BUREAU OF INDIAN STANDARDS**AGENDA**

Panel for Steel, CED 46:P9 : **Sixth Meeting**

Panel for Revision of IS 800, CED 07:2:P1

Friday, 21 June 2024 : **1030 h**

Table 23 Response Reduction Factor, R , for Building System
(Clause 18.3)

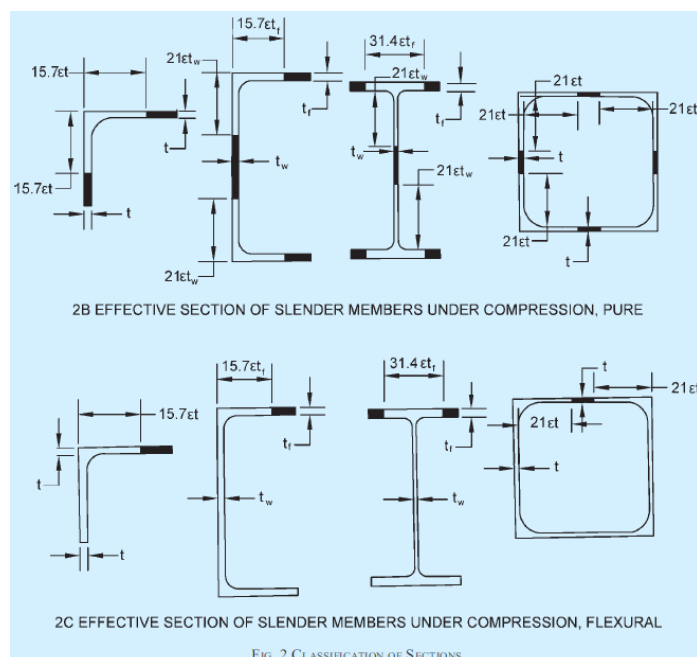
- 7) High-rise all steel buildings which have less than 5% of today's market. We need to address the specific points.
 - a) Chapter – 12
 - b) Fire Protection
 - c) Necessity for second-order analysis
 - d) Connections
 - e) Effective length.
- 8) All the Amendments will be integrated into the First revision of IS:800 (2007).
- 9) All changes we incorporated in Section 6-6 of NBC will be updated in the First revision.
- 10) NBC corrections are majorly on (i) slender webs (ii) complete of Fatigue Chapter and (iii) non-ductile frames.
- 11) Update Clause 3.7.2 about slender elements in tune with Section 6 of NBC.

3)	<p>IS 800 -2007 Table 23 1893 (Part 1) NBC-2016</p> <p>IS 1893 (Part 1) -2016 Table is 9</p> <p>NBC-1026 - Clause 18.3 Part-6, Section-6, DESIGN & DETAILING</p>	Technical	Interarch	<p>The Response Reduction Factor is 4 for OMF as per IS 800 -2007 Table 23 1893 (Part 1) -2016 is 4 (Page 87)</p>	<p>Usage of lower value of R = 1.5 makes the design considerably heavy. We request code committee to re-look into above clauses and define response reduction factor as 4 for low rise</p>

<p>FOR EARTHQUAKE LOADS (page 85) for Response Reduction Factor</p> <p><u>Attachments:</u> Page 87 -IS 800 2007 Page 20 IS 1893 2016 Page 85 - NBC 2016</p>			<p>The Response Reduction Factor is 3 for OMF as per IS 1893 (Part 1) -2016 Table is 9 (Page 20)</p> <p>The response reduction factor is 4.0 for OMF as per NBC-2016.</p> <p>However, there is also a mention about non-ductile frames for low rise buildings of height to width ratio which does not exceed 1.0</p> <p>All the 3 cases are hard to correlate and very confusing. Hence we suggest to have the R to be uniformly defined as 4.0 across all the codes.</p>	<p>buildings with an exemption for Section 12 – IS 800 2007</p>
--	---	--	--	---	---

The braced and moment resisting frames can be designed as non-ductile frames, if their overall height to overall width ratio does not exceed 1.0, such as in industrial buildings. Such frames need not meet the ductility requirements of other types of frames as specified in 18.4 to 18.11 and 18.13.
